DESCRIPTION OF WORK: 1. REMODEL FORMER MEN'S LOCKER, SHOWER, SUNA, AND RESTROOM FACILITIES FOR USE BY WOMEN TO GAIN A DIGNITY BETWEEN MEN'S & WOMEN'S FACILITIES. 2. INSTALL A NEW ARTICLE IS ELEVATOR TO PROVIDE A PATH OF TRAVEL TO THE REMODEL AREA. 3. ALTER & / OR REMODEL OTHER FEATURES, TO PROVIDE ACCESS, INCLUDING MEN'S RESTROOM, STAIRWAYS, DOORS, AND SIGNAGE.

DOLPHIN CLUB
S WIMMING & BOATING
SAN FRANCISCO
ORGANIZED 1977
LOCKER ROOM & SHOWER EXPANSION

SITE/ROOF
PLAN; GENERAL
INFORMATION

NOTE:
 1. RESTORE ALL EXIS. CONSTRUCTION & ASSEMBLIES TO REMAIN WHICH WERE DAMAGED IN DEMOLITION OR CONSTRUCTION.
 2. REINSTALL ALL FIXTURES, SWITCHES, & DEVICES TO REMAIN WHICH WERE DISRUPTED BY CONSTRUCTION.

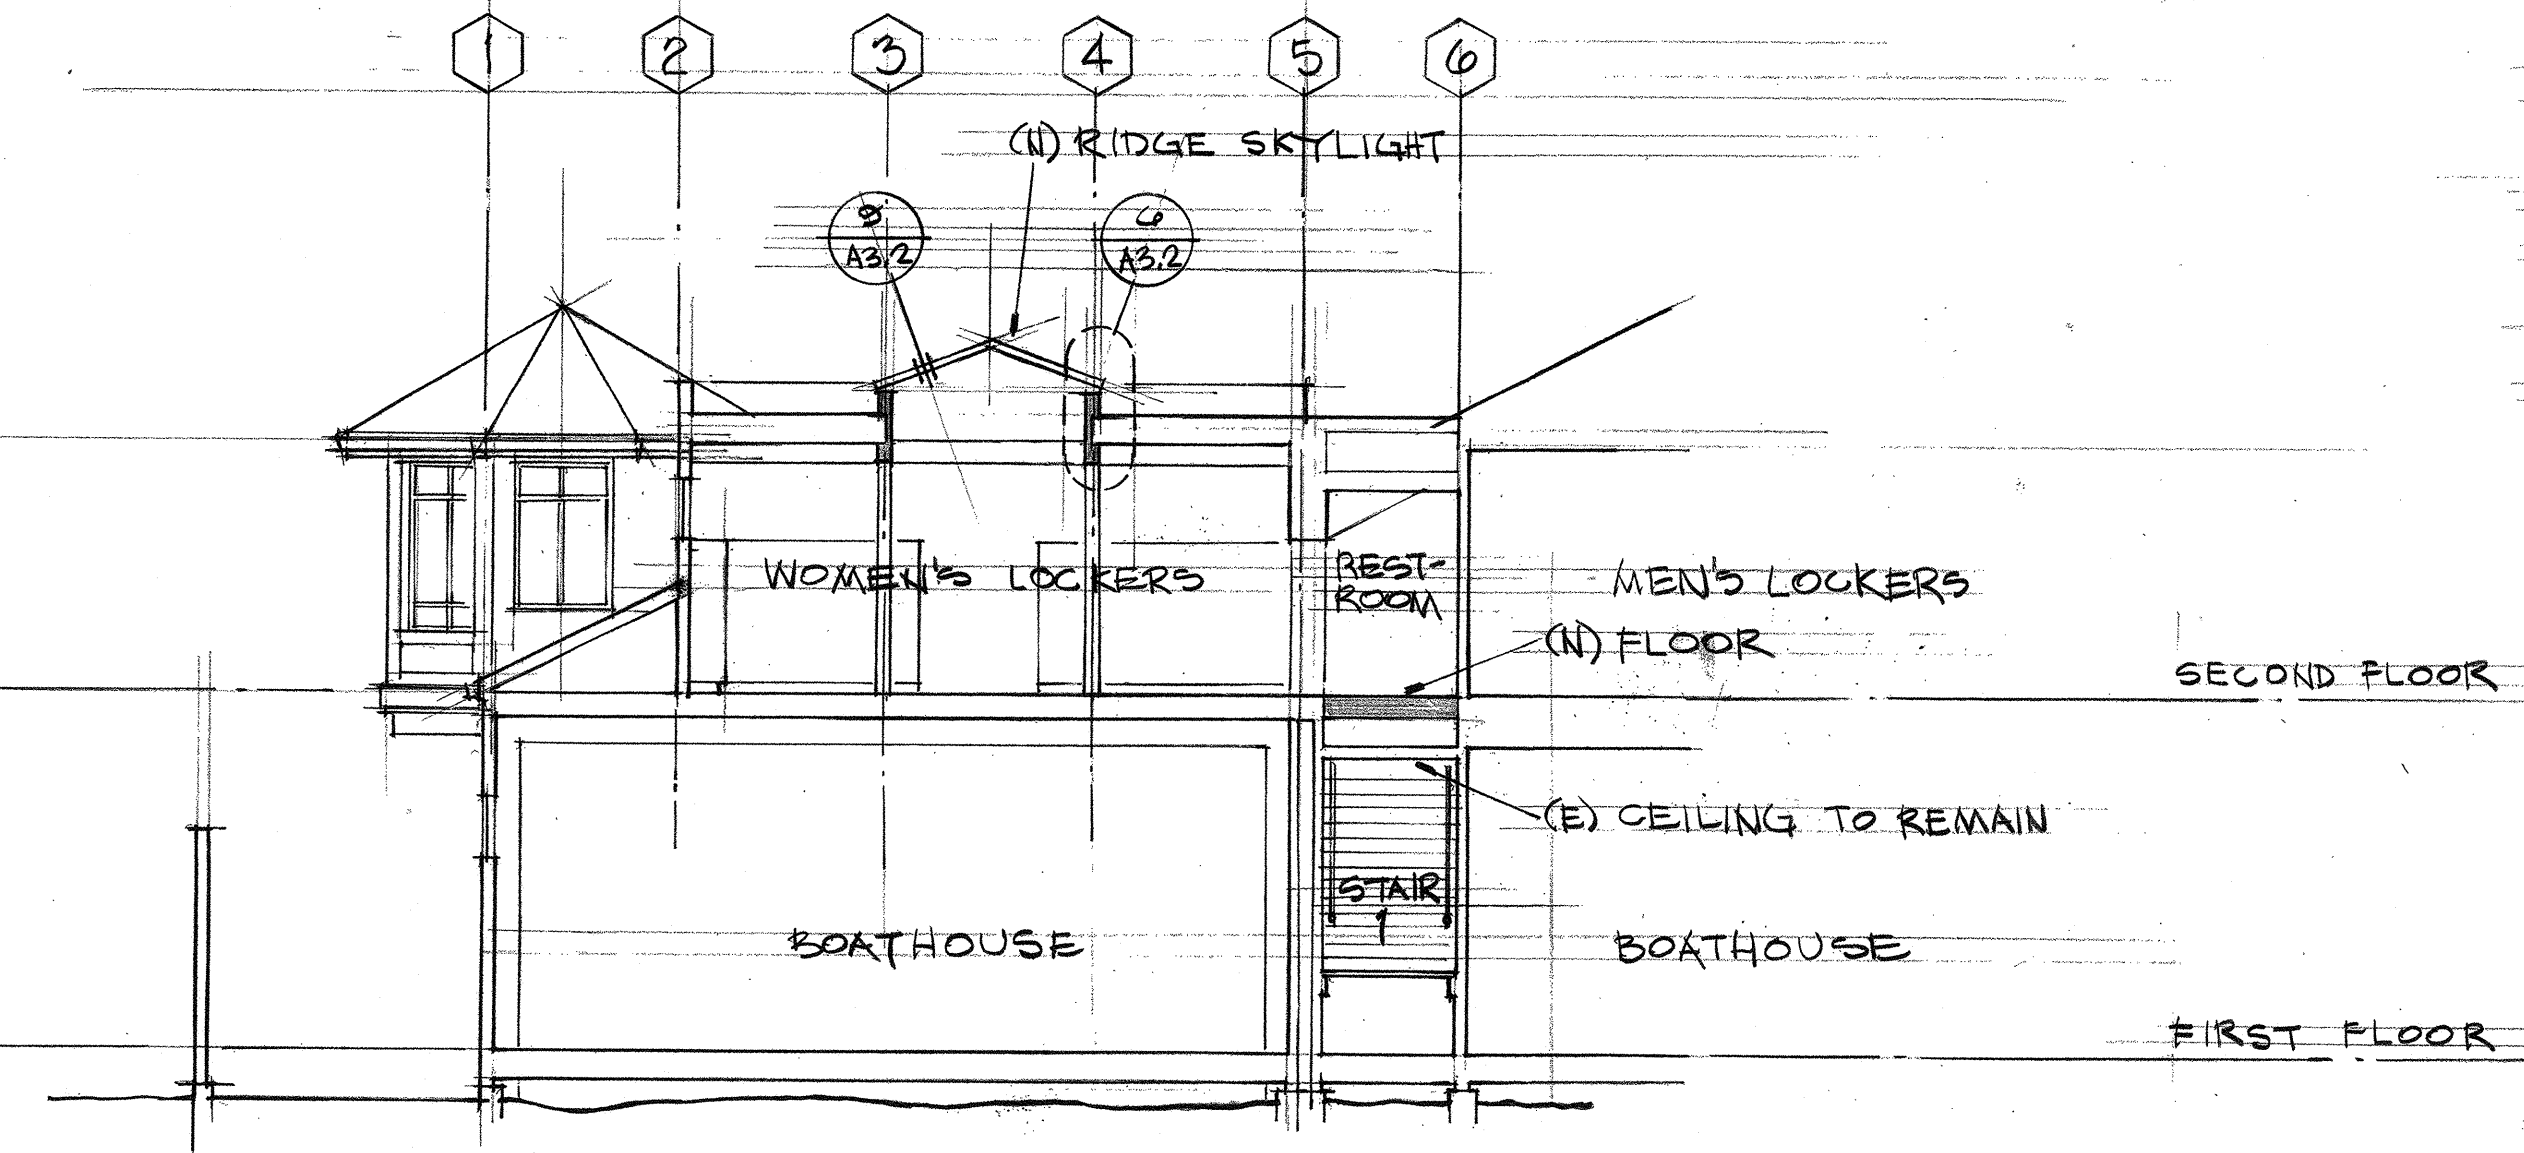
REVISIONS:
 1. ARTICLE 13 ACCESSIBLE LIFT ADDED.
 2. WOMEN'S LOCKER ROOM LAYOUT REVISED.
 3. SHEET NUMBER CHANGED.

⑥ CROSS-SECTION A
1/8" = 1'-0"

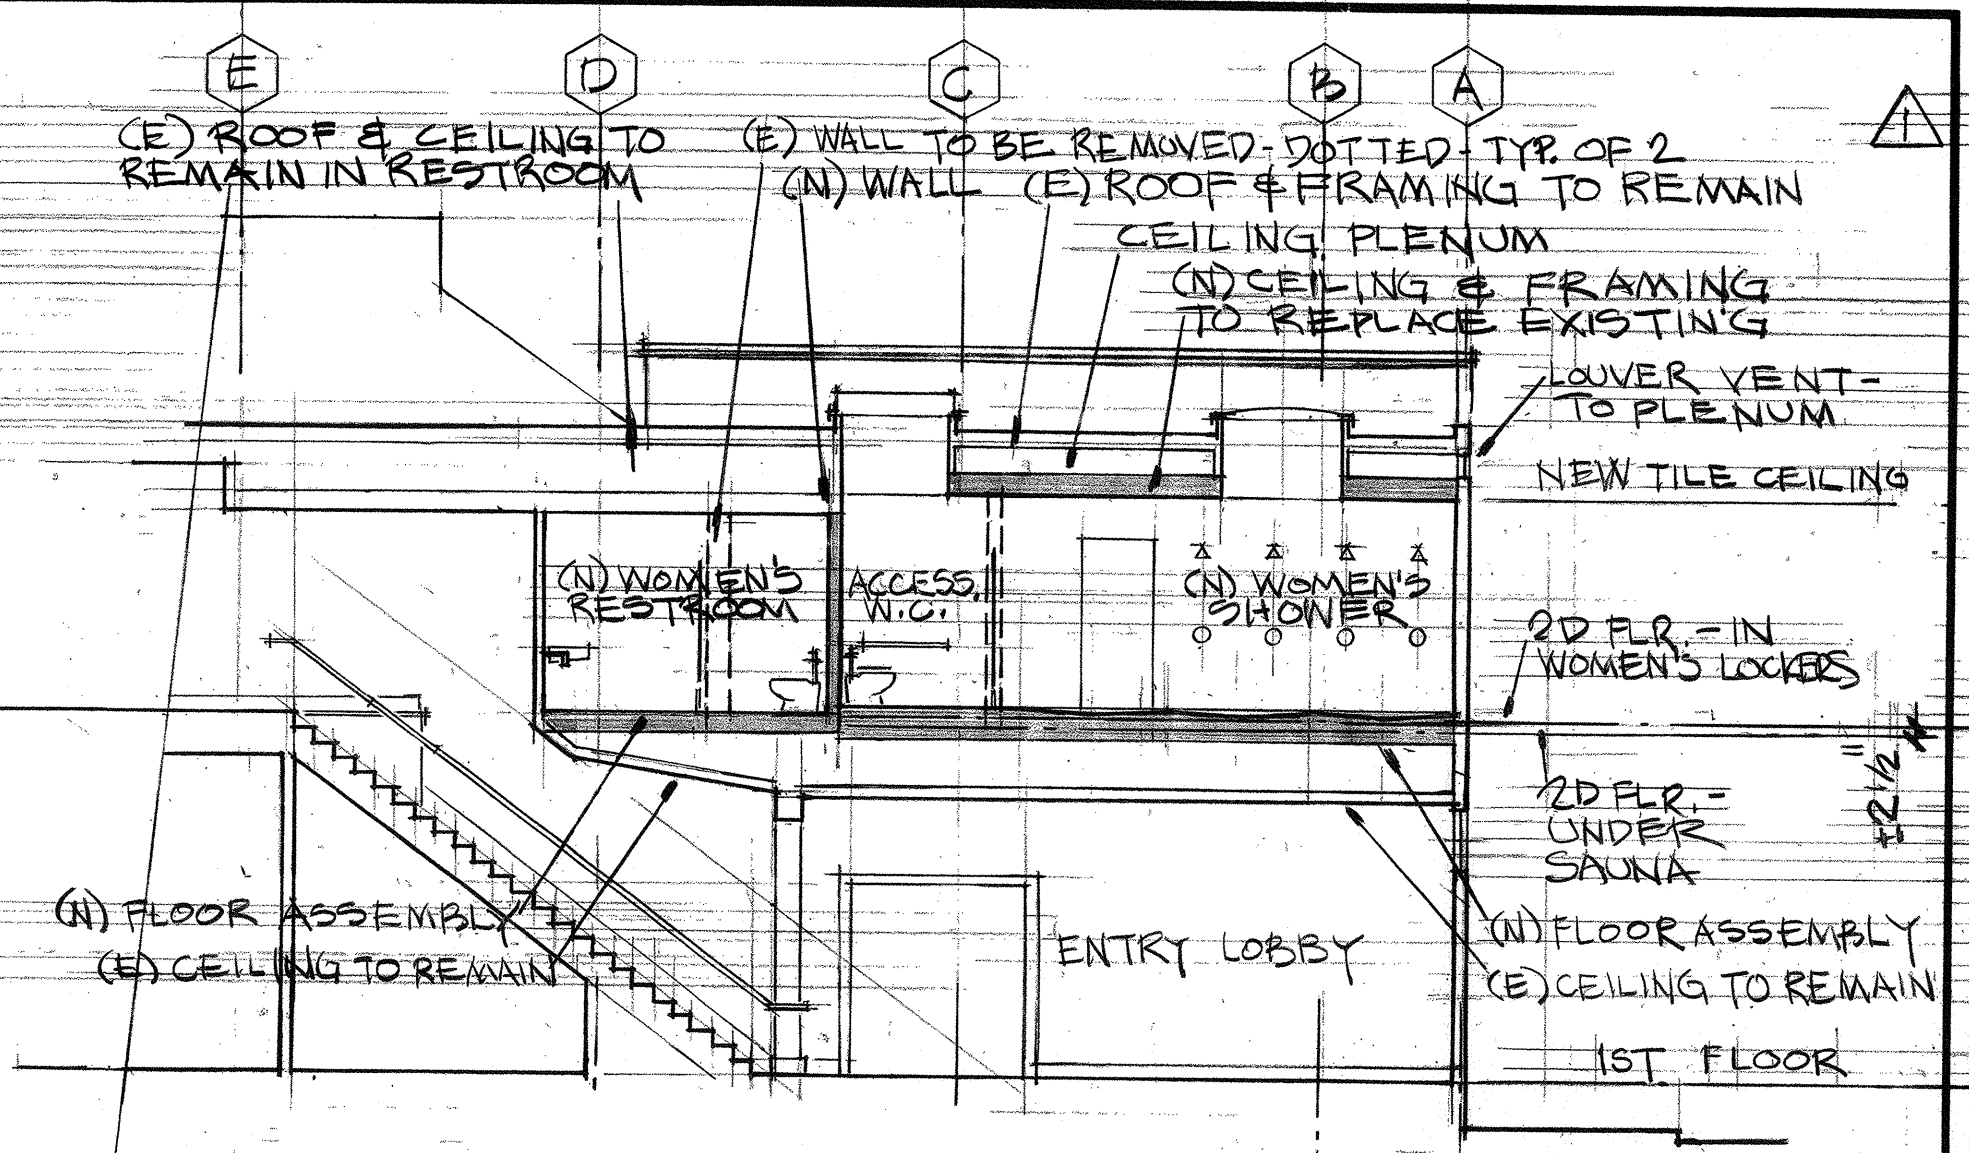
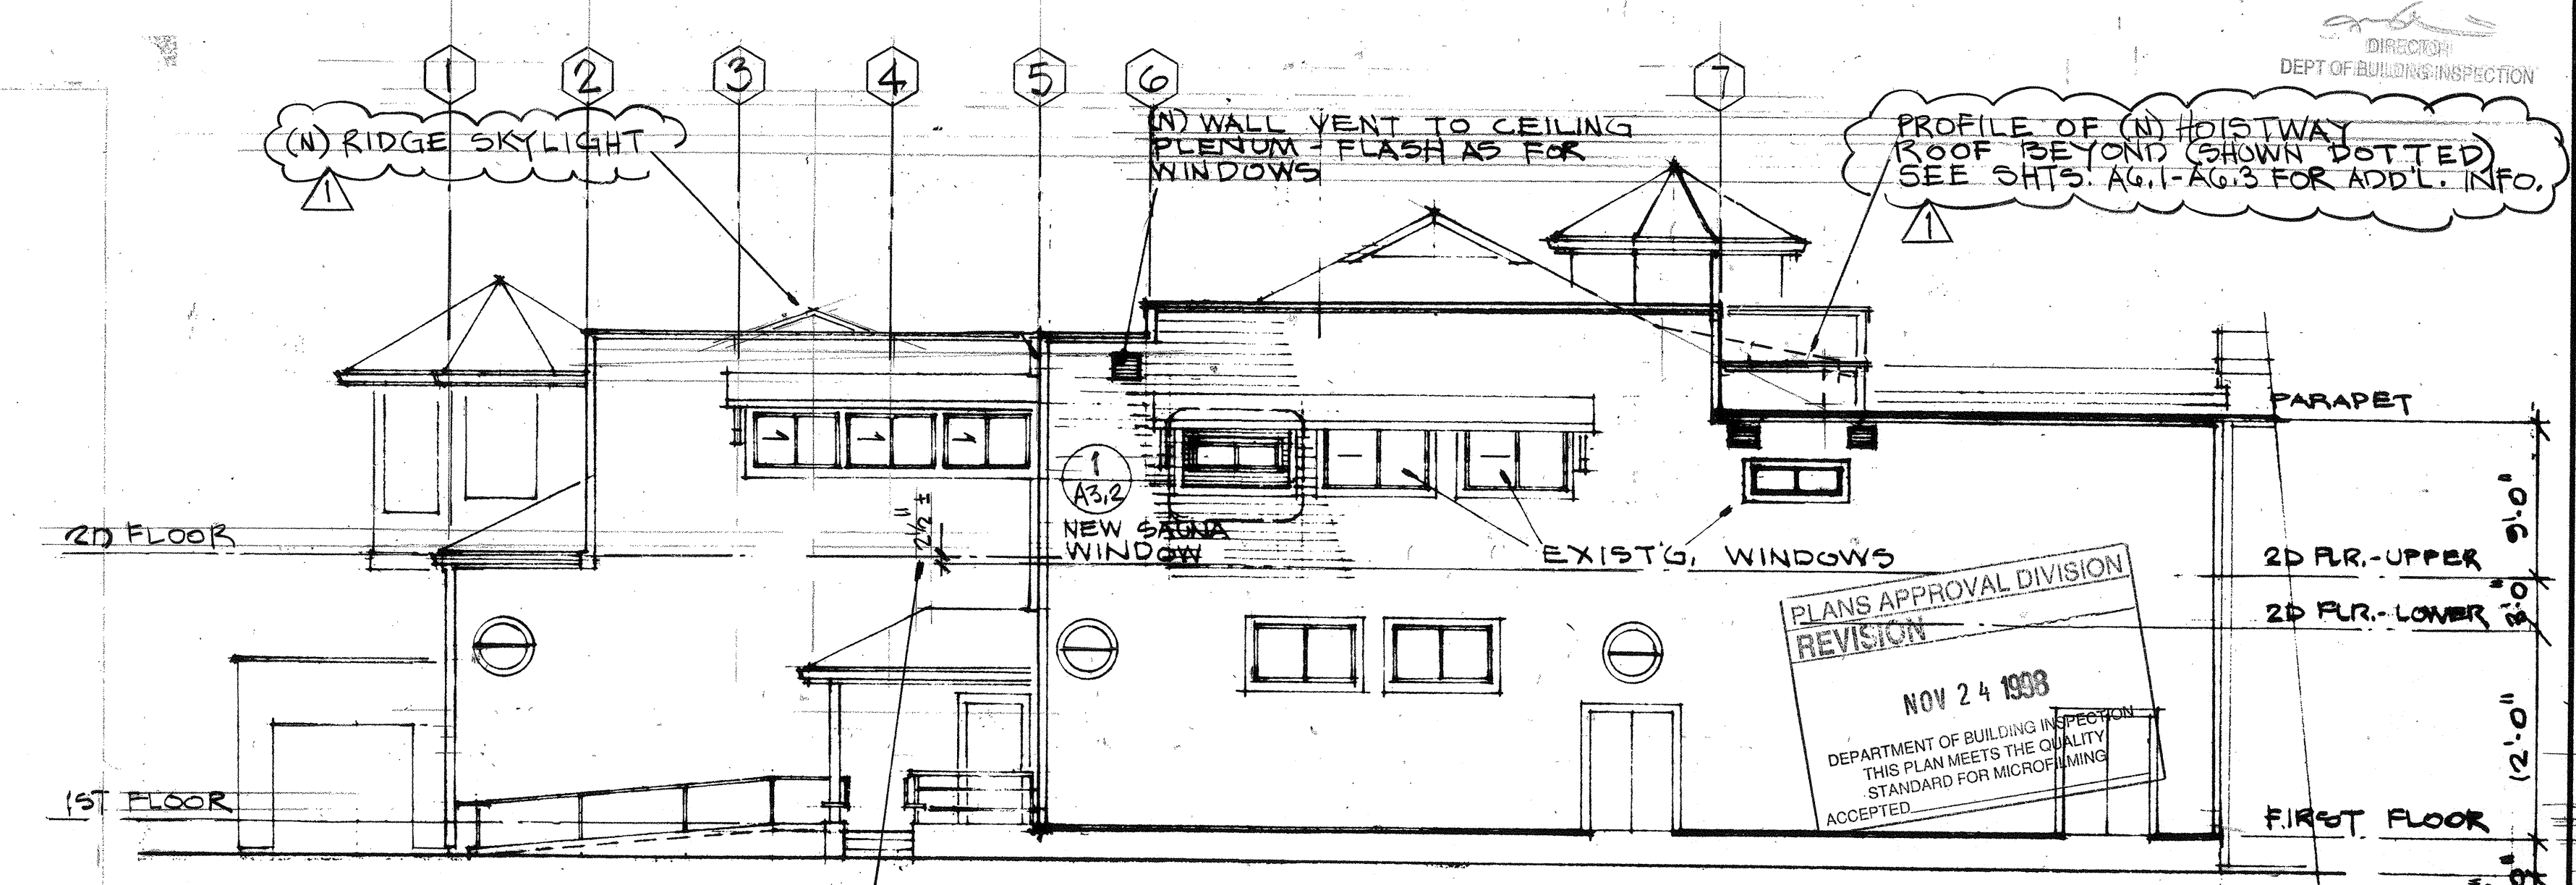
REVISIONS: A
1. ARTICLE 13 LIFT SHOWN (BEYOND).
2. RIDGE SKY LIGHT SHOWN.
3. SECTIONS ADDED.
